Remarks: Re: DA N° 2010/138 - 383 Waterfall Way Fernmount.

Perrys Tourist Development – Waterfall Way, Fernmount
Additional Information on Proposed Access Roads

Perrys Tourist Development – Waterfall Way, Fernmount
Additional Information on Proposed Dam Enlargement

Integrated Development for A/184353 383 Waterfall Way Fernmount 2454

TYPICAL CROSS-SECTION

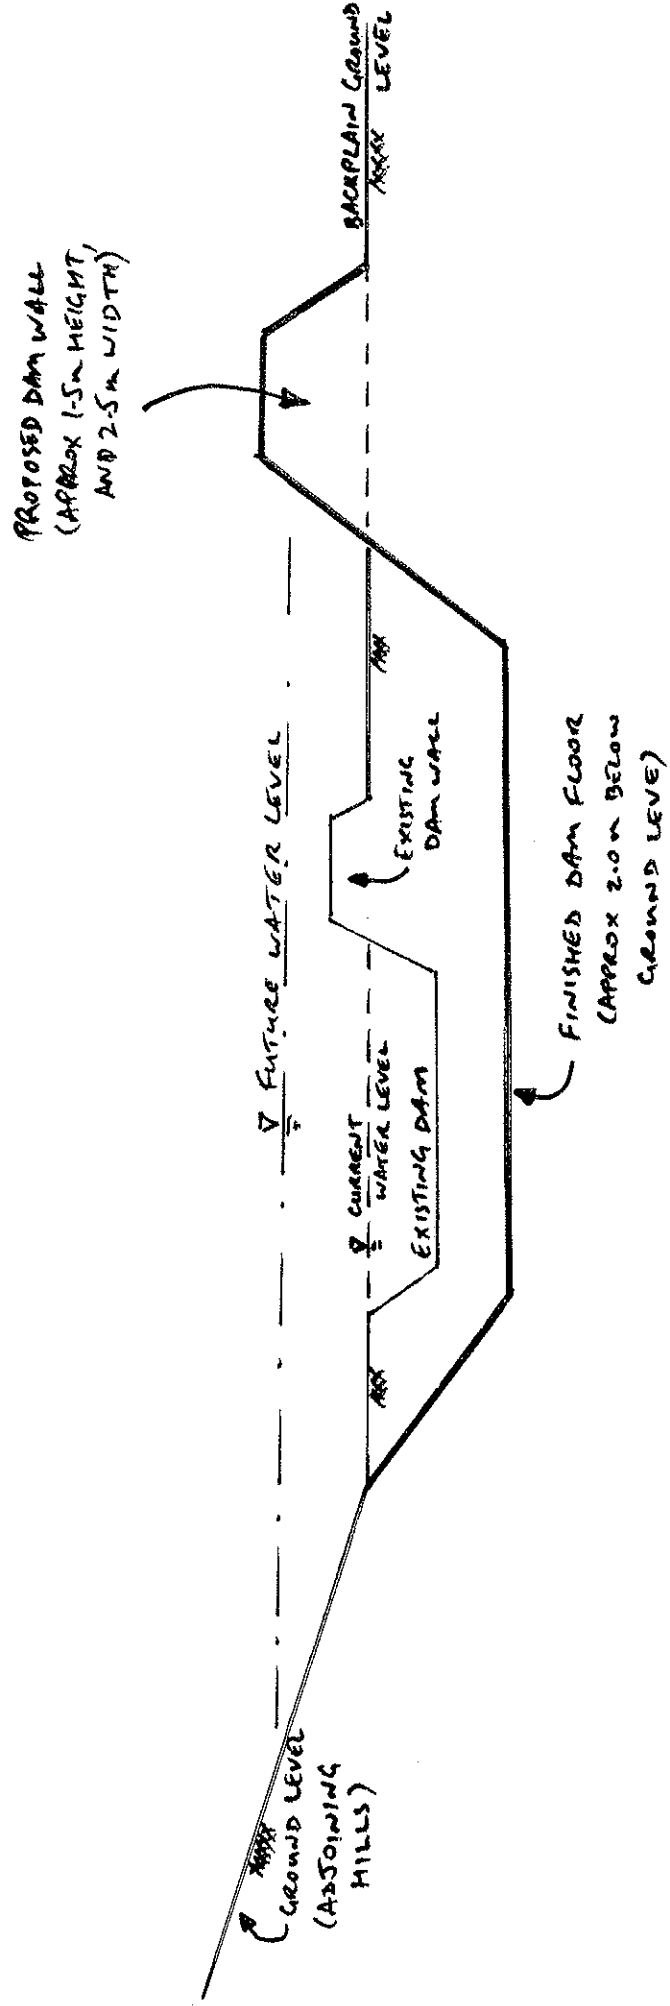
The enlargement of an existing onsite dam was included as part of the proposed development. Council has requested additional information on the proposed enlargement of the dam, including:

- More detail on the design of the dam, including works to be carried out;
- An assessment on the potential acid sulfate soil (ASS) impacts from undertaking the works on the dam; and
- A cross-section drawing of the dam.

It is proposed to enlarge the existing dam by forming a new higher dam wall 15 – 20 metres to the east of the existing dam. The new dam wall would be approximately 1.5 metres in height, and would be formed by excavating up to 2.0 metre depth of insitu backplain material within the new dam area. The finished area of the dam is estimated to be less than 2000 m², with a standing water depth of approximately 3.0 metres, and a freeboard of 0.5 metres.

A cross-section profile of the dam is provided in the attached figure.

In addition, the proposed limited depth of excavation (< 2.0 metres) to form the dam will also minimise any potential exposure of ASS, if they do happen to occur at the subject location.
